RESPONDENT	COMMENT	RESPONSE
Councillor Ruth Wilkinson (City Council)	<p>The current condition of London Road is desperately poor. Resurfacing of the road is of prime importance. Any improvements related to this scheme should only be carried forward once the necessary budget for repairing London Road is set aside as top priority.</p> <p>Concerned about the safety of cyclists and any potential mixing between cyclists and buses. The cycle hire scheme will result in more people cycling to work in Headington – provision of a mandatory inbound cycle lane from the Green Road roundabout should be considered.</p> <p>What effect will the new length of bus lane on the A40 (west) approach have on traffic using the segregated left turn lane from the A40 on the A4142 Eastern Bypass road?</p> <p>There is difficulty with egress onto London Road from Lyndworth Close and Northfield Road – yellow box markings should be provided.</p>	<p>Noted. Although partially funded by the LSTF, the principle aim of the London Road Improvement Scheme has been to provide bus priority along this important route into Headington. The proposals as consulted on seek to maintain current levels of cycling provision.</p> <p

Drawing No. S-000634/CON/000/001 Revision 0

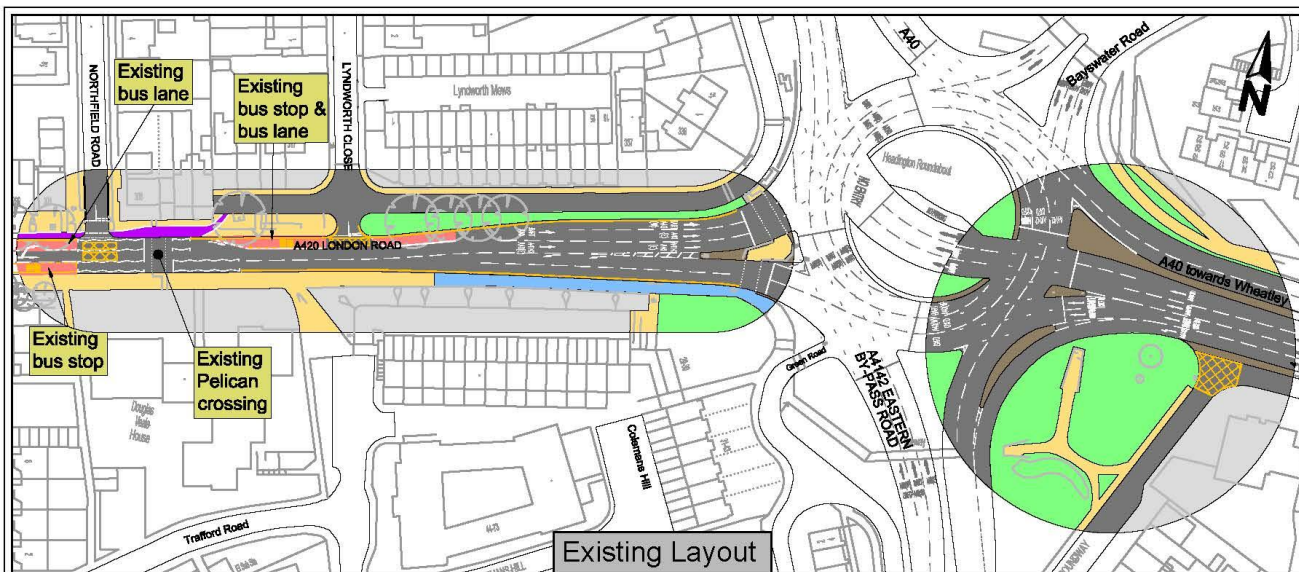
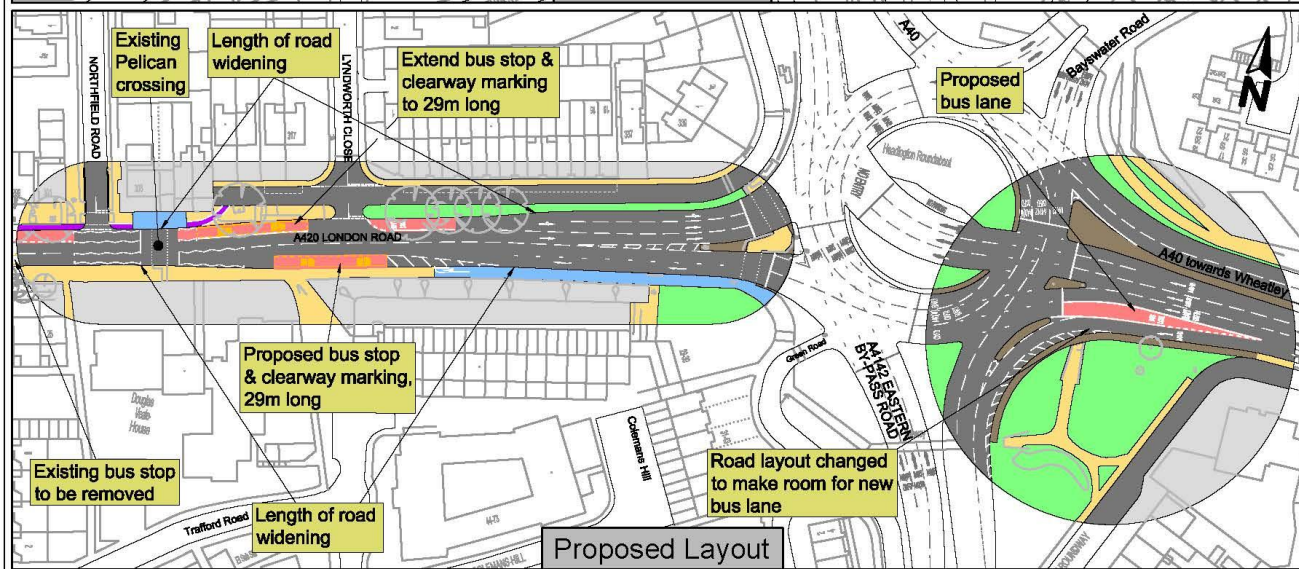
<p>Local resident</p>	<p>Allow general traffic on the A40 (west) wanting to turn left onto the A4142 Eastern Bypass to use the bus lane on the A40 to avoid queuing traffic.</p> <p>The current arrangement for cyclists crossing the Green Road roundabout by using the subways is unclear.</p> <p>Expressed concern about the impact of traffic by</p>	<p>Allowing left turning traffic into the existing bus lane on the A40 would undermine the status of the bus lane and leave it open to unlawful use.</p> <p>Although partially funded by the LSTF, the principle aim of London Road Improvement Scheme has been to provide bus priority along this important route into the Headington. The proposals as consulted on seek to maintain current levels of cycling provision.</p>

<p>On line response</p>	<p>A small section of bus lane will have little effect on journey times, and cause considerable delays for others.</p>	<p>The provision of a short length of bus lane on the A40 (west) approaching the Green Road roundabout will give significant advantage to buses by allowing them to pass stationary traffic. There will be little or no impact on other traffic as the segregated left turn lane onto the A4142 Eastern Bypass will operate as it does at the moment.</p>

<p>On line response (Bus Users UK)</p>	<p>Would like a stop line for general traffic on the offside of inbound bus lane at roundabout moved back by 10 metres, to give buses a 'head start' onto roundabout. Consider providing give way markings on the general traffic lane adjacent to the relocated inbound bus stop to give buses priority over general traffic.</p>	<p>This would require additional traffic signal infrastructure for little additional benefit.</p> <p>An unconventional use of give way markings might potentially confuse road users.</p>

RESPONDENT	COMMENT	RESPONSE
On line response	A short section of bus lane just before traffic lights at the roundabout will be restrictive to other road users. The proposed bus lane will have little effect on bus journey times.	The provision of a short length of bus lane on the A40 (west) approaching the Green Road roundabout will give significant advantage to buses by allowing them to pass stationary traffic. There will be little or no impact on other traffic as the segregated left turn lane onto the A4142 Eastern Bypass will operate as it does at the moment.
On line response	What is the evidence that a short bus lane will reduce bus journey times? Any gains are lost further down the road. This is a dangerous stretch for cyclists and this scheme will make it worse. Create a cycle lane on the footway.	<p>Although partially funded by the LSTF, the principle aim of the London Road Improvement Scheme has been to provide bus priority along this important route into Headington. The proposals as consulted on seek to maintain current levels of cycling provision.</p> <p>In order to address the concerns raised by the cycling groups in relation to the merging of cyclists on the existing off carriageway shared use footway/cycleway and general traffic and it is recommended that the proposal as consulted on be reviewed during the detailed design stage.</p>

<p>Local resident</p>	<p>Very pleased that there is a bus lane planned between Green Road roundabout. and Gladstone Road. Not sure about a bus lane on the roundabout as it is confusing enough anyway.</p>	<p>No bus lanes are proposed for the roundabout itself.</p>

RESPONDENT	COMMENT	RESPONSE
	<p>converting one of the straight ahead lanes on the A40 (west) to a bus lane.</p>	<p>In order to address concerns raised by the cycling groups in relation to the merging of cyclists on the existing off carriageway shared use footway/cycleway and general traffic it is recommended that the proposal as consulted on be reviewed during the detailed design stage.</p>
<p>On line response</p>	<p>Footways are wide enough to place bus lanes on both sides of London Road right through extent of scheme. The existing footways should be converted to shared use status for pedestrians and cyclists.</p> <p>The existing signal controlled crossing located on the London Road exit from the roundabout should be relocated further west away from the roundabout.</p>	<p>Although partially funded by the LSTF, the principle aim of the London Road Improvement Scheme has been to provide bus priority along this important route into Headington. The proposals as consulted on seek to maintain current levels of cycling provision.</p> <p>In order to address the concerns raised by the cycling groups in relation to the merging of cyclists on the existing off carriageway shared use footway/cycleway and general traffic, it is recommended that the proposal as consulted on be reviewed during the detailed design stage.</p> <p>The existing signal controlled crossing referred to forms part of the overall signal control system at the roundabout and serves an important function of giving cyclists access to routes leading to key destinations.</p>

RESPONDENT	COMMENT	RESPONSE
		<p>The provision of an offset bus layby on London Road will also address the problem of 'exit-blocking' on the roundabout.</p>
<p>On line response</p>	<p>Data should be provided to see if there has been an improvement in journey times from the previous London Road improvement schemes, and to see if good value for money is achieved for tax payers.</p>	<p>This information can be obtained through a Freedom Of Information request if required.</p>
<p>On line response</p>	<p>The stretch of London Road from the relocated inbound bus stop to Gladstone Road should be developed as a bus lane, for use by cyclists.</p> <p>A new bus stop specifically for London to Oxford coaches should also be provided.</p>	<p>Although partially funded by the LSTF, the principle aim of the London Road Improvement Scheme has been to provide bus priority along this important route into Headington. The proposals as consulted on seek to maintain current levels of cycling provision.</p> <p>In order to address the concerns raised by the cycling groups in relation to the merging of cyclists on the existing off carriageway shared use footway/cycleway and general traffic and it is recommended that the proposal as consulted on be reviewed during the detailed design stage.</p> <p>There are currently no proposals to review bus stop facilities on London beyond the scope of the Improvement Scheme.</p>
